MAGNASTOR[®]

Amendment 15
Supplement 01

Proposed Certificate of Compliance Changes

**MAGNASTOR® FSAR
Amendment 15 Supplement 1
Revision 23E**

Figure 4.10-6 Maximum Fuel Temperature vs. Time for Vacuum Drying – 35.5 kW

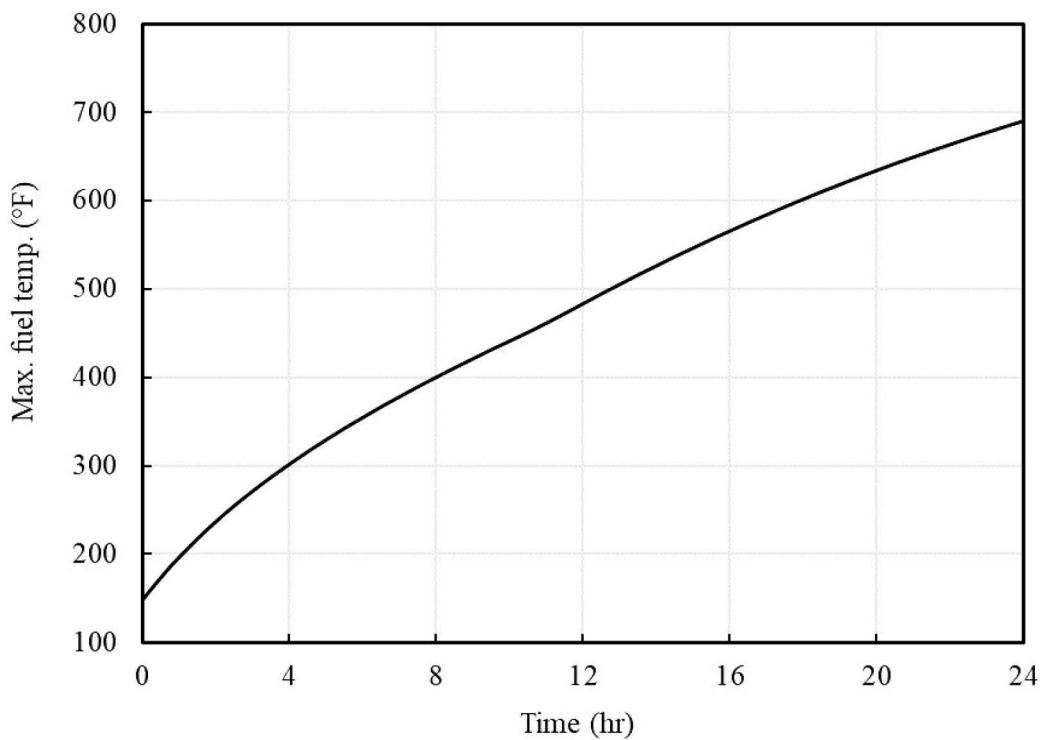
- Pages 4.10.3-2, revised Section 4.10.3.4 where indicated
- Pages 4.10.4-1, revised Section 4.10.4.2 where indicated
- Pages 4.10.4-2, revised Section 4.10.4.3 where indicated
- Pages 4.10.4-4, replaced Figure 4.10-6
- Pages 4.10.4-5, replaced Figure 4.10-7
- Pages 4.10.4-6, revised Tables 4.10-1 and 4.10-2 where indicated

The transient analyses are performed for 24 hours for the total heat load of 35.5 kW. The maximum temperatures of the fuel cladding and basket are presented in Table 4.10-1. The maximum fuel temperature as a function of time for the vacuum drying phase is shown in Figure 4.10-6.

Figure 5.17.1-1 Modeled TSC Closure Lid Recess Location

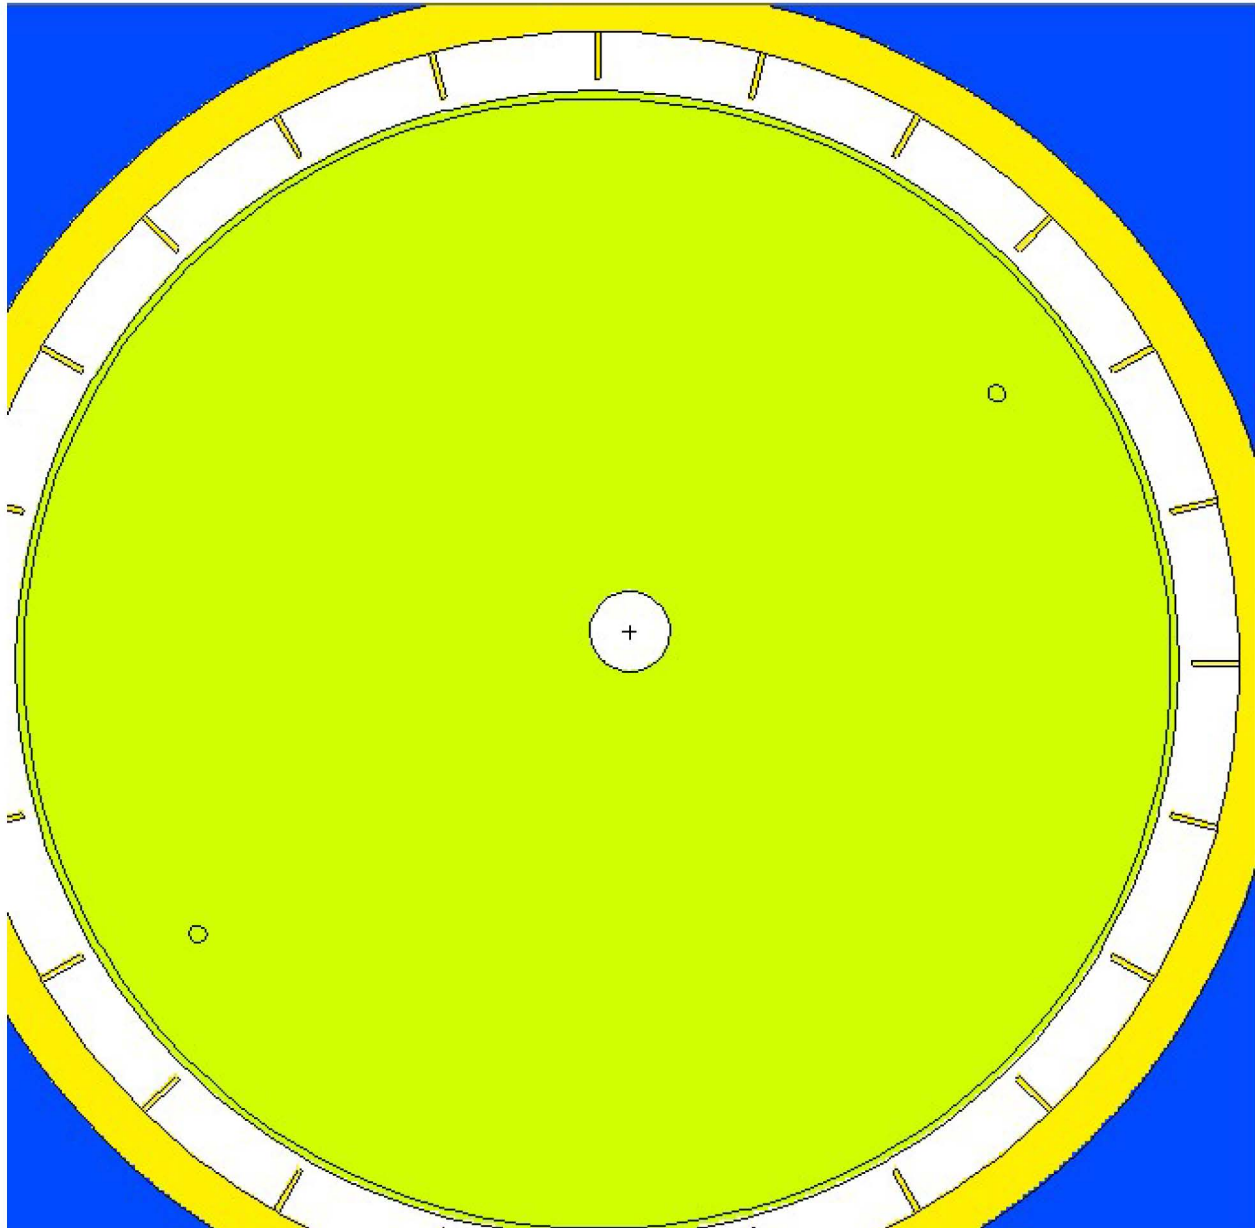
- Pages 5.17-1 thru 5.17.3-2, added new Section 5.17

Other than the recess in the TSC closure lid, no changes are required to the previously-developed models of the PMTC and CC5. The closure lid recess is 3 inches deep with a 5-inch OD, slightly offset from the center of the basket as shown in Figure 5.17.1-1.

Figure 5.17.2-1 PMTC Configuration 1 Model Top Dose Rate Profile Comparison

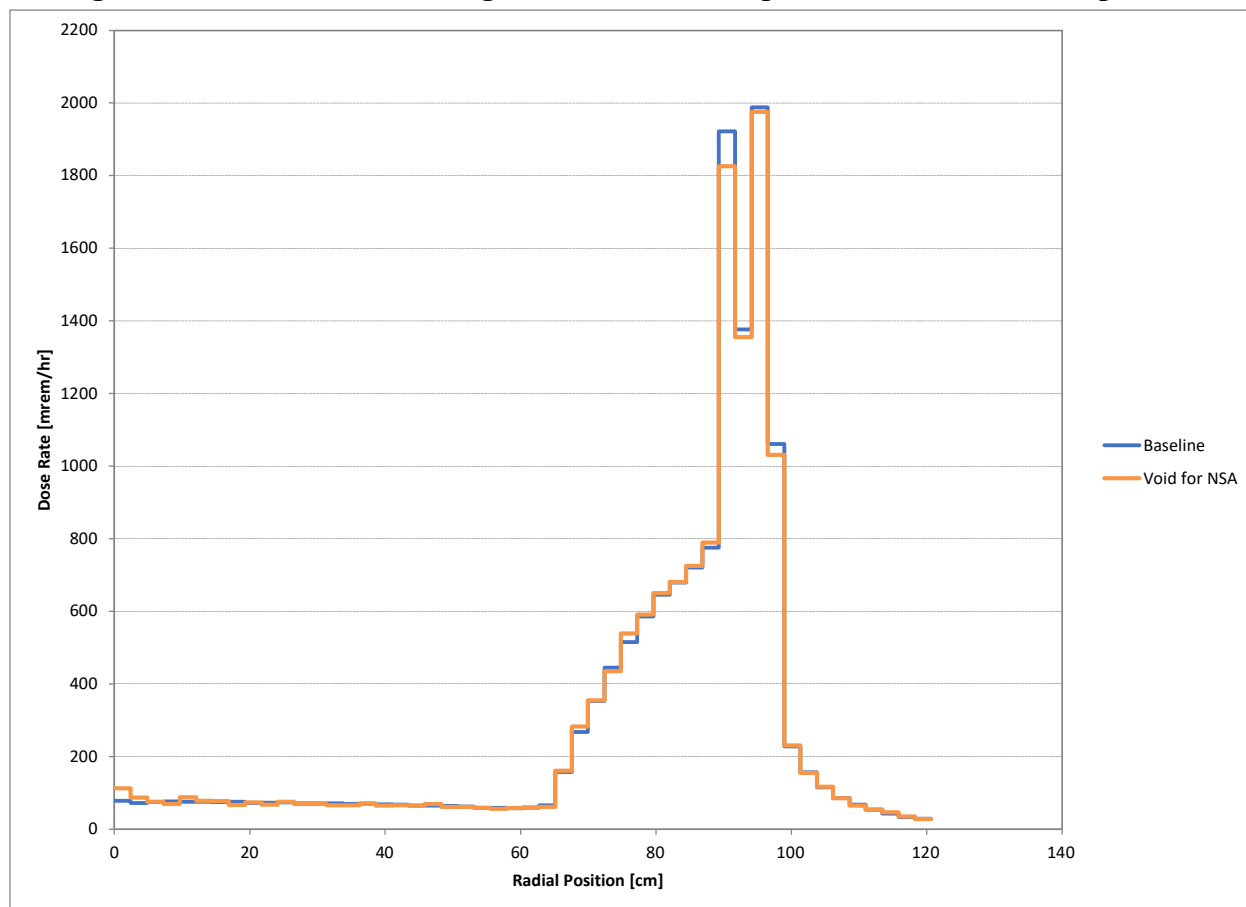
Results for the PMTC are shown in Figure 5.17.2-1 and Figure 5.17.2-2. In the figures, “Baseline” denotes the no recess results and “Void for NSA” denotes the lid recess results. As expected, dose rates increase at the cask centerline for both models. Dose rates at the TSC-to-cask annulus and over the entire surface decrease for the Configuration 1 model and increase for the Configuration 2 model. The TSC-to-cask annulus peak for the Configuration 2 model is within 2σ of the no recess dose rate. Due to the very small uncertainties over the entire surface, a greater than 2σ increase in the average is observed. However, an increase of 2% is deemed as not significant based on typical uncertainties, which often exceed 1%. As the peak locations are within 2σ , and this location is bounding for occupational exposures, occupational exposures will not significantly increase.

Based on the rationale above, the recess in the TSC closure lid is acceptable for the PMTC.

Figure 5.17.3-1 CC5 Top Dose Rate Profile Comparison

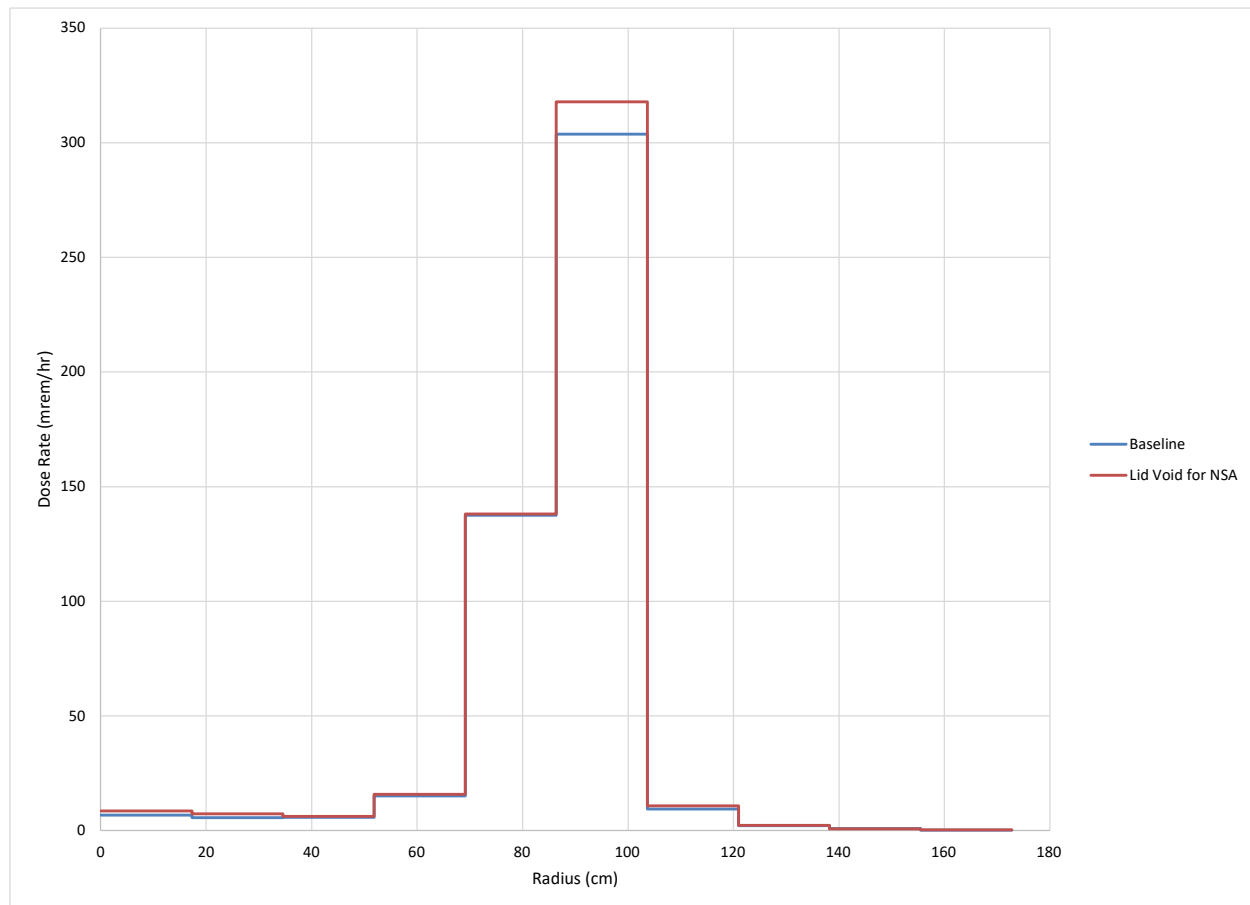
Results for the CC5 are shown in Figure 5.17.3-1. As expected, the dose rate increases at the cask centerline. This increase is greater than 2σ of the no recess dose rate. Increases are also observed at the peak over the TSC-to-cask annulus and over the entire surface. The increase at the peak is within 2σ of the no recess dose rate. The increase over the entire surface is within 0.1% of 2σ . This is deemed as a non-significant effect on site boundary dose rates, which are governed by average surface dose rates.

Based on the rationale above, the recess in the TSC lid is acceptable for the CC5.
